Re: Freeport-McMoRan Chino Mines Company- Updated Closure/Closeout Plan Continental Mine and Hanover Mountain Mines, Permit No. GR002RE, Response to Agencies' Comments and Request for Additional Information

Freeport-McMoRan Chino Mines Company (Chino) submitted an application to renew the Continental Mine Closure/Closeout Plan (CCP), Permit GR002RE on July 31, 2023. On November 6, 2023, Mining and Minerals Division (MMD) determined the application to be administratively complete. On November 20, 2023, an interagency inspection of Continental and Hanover Mountain Mines was conducted. In a letter dated February 19, 2024, Mining and Minerals Division (MMD) requested supplemental information and submitted a combined agency review comments and Request for Additional Information (RAI) from the following state agencies: New Mexico Mining and Minerals Division (MMD), the New Mexico Environment Department (NMED), the New Mexico Department of Game and Fish (NMDGF), and the New Mexico Department of Cultural Affairs - Historic Preservation Division (NMDCA/HPD), and the New Mexico State Forestry Division (NMSFD).

FIGURE 9
INDUSTRIAL POST-MINING LAND USE

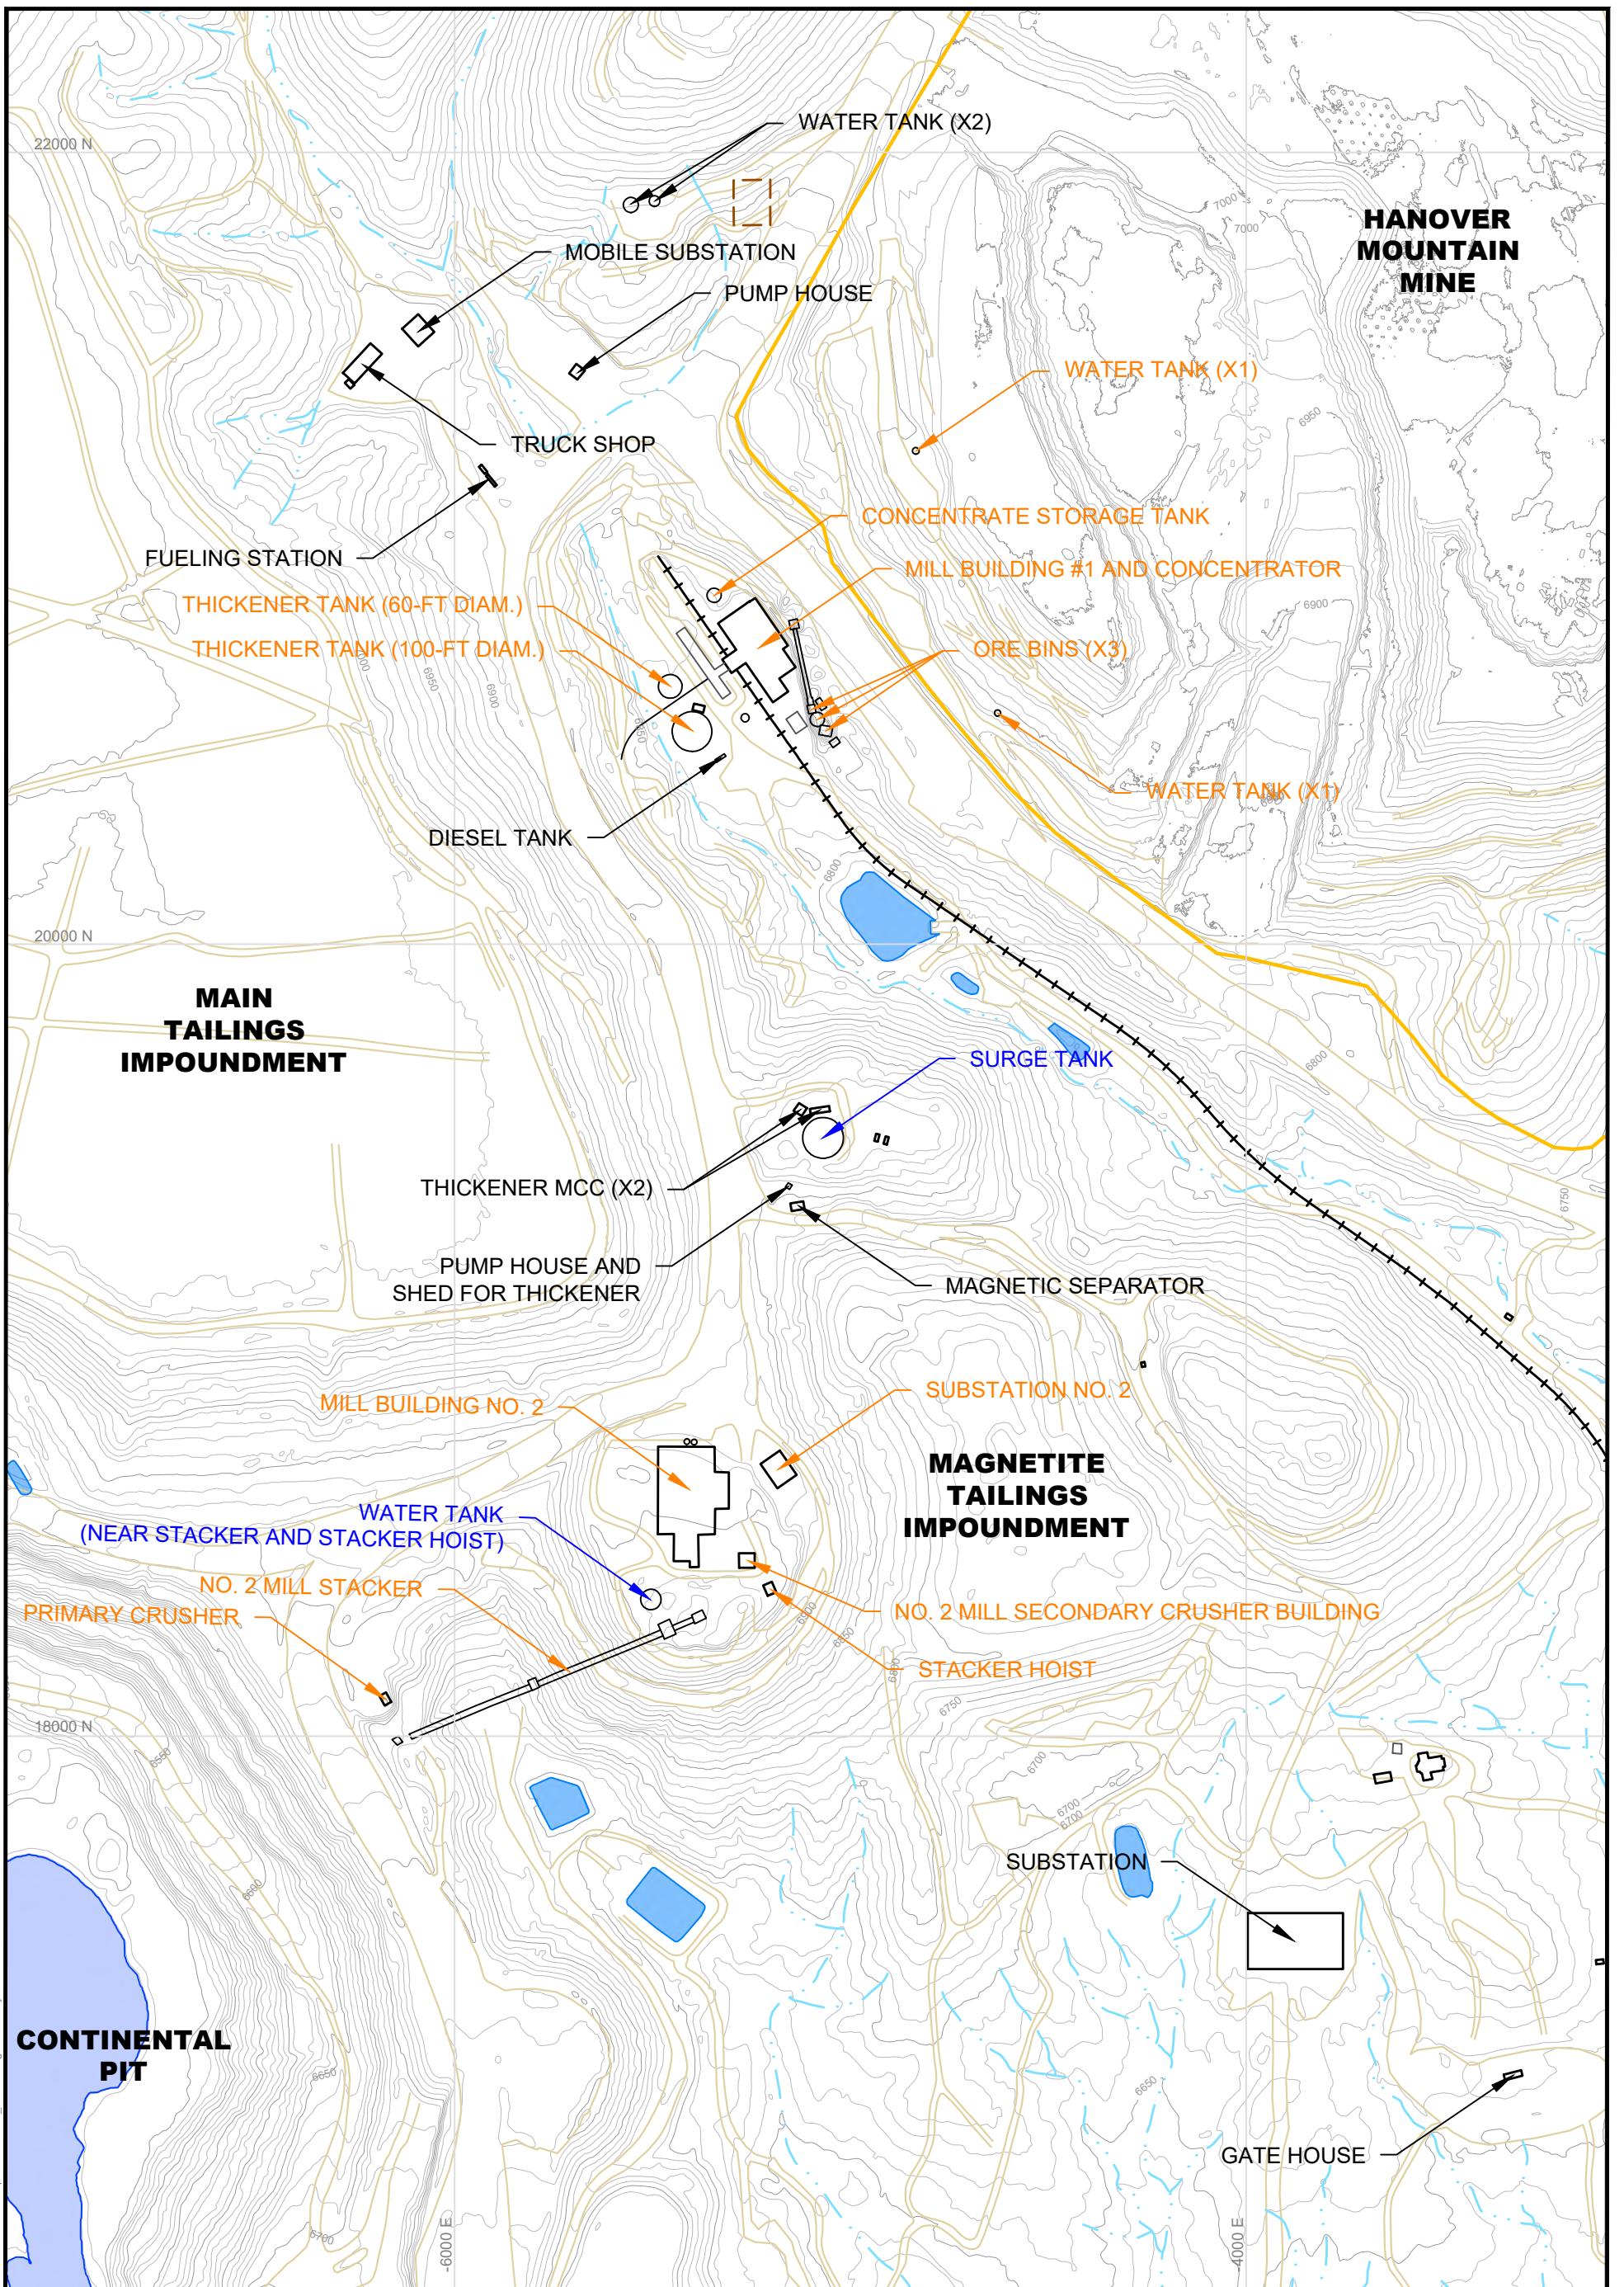
16. Table 8 and Figure 9, Building/Tank/Structure Closure Plan. This table has several items as Removed Prior to 2026 and Removed at Closure. Please clarify if the Removed Prior to 2026 means structures have been removed in 2023 or will be removed sometime between 2024-2026.

17. Table 8 and Figure 9, Building/Tank/Structure Closure Plan. Consider adding another category indicating if any demolition is anticipated in the next 5 years, such as the No. 2 Mill Stacker and Secondary Crusher Building.

Items under the 'Removed Prior to 2026' will be removed between 2024-2026. Please see the attached revised Table 8 and Figure 9.

Chino Mines current forecast includes demolition of Mill's 1 and 2 within the next five years. Please see updated Table 8 and Figure 9.
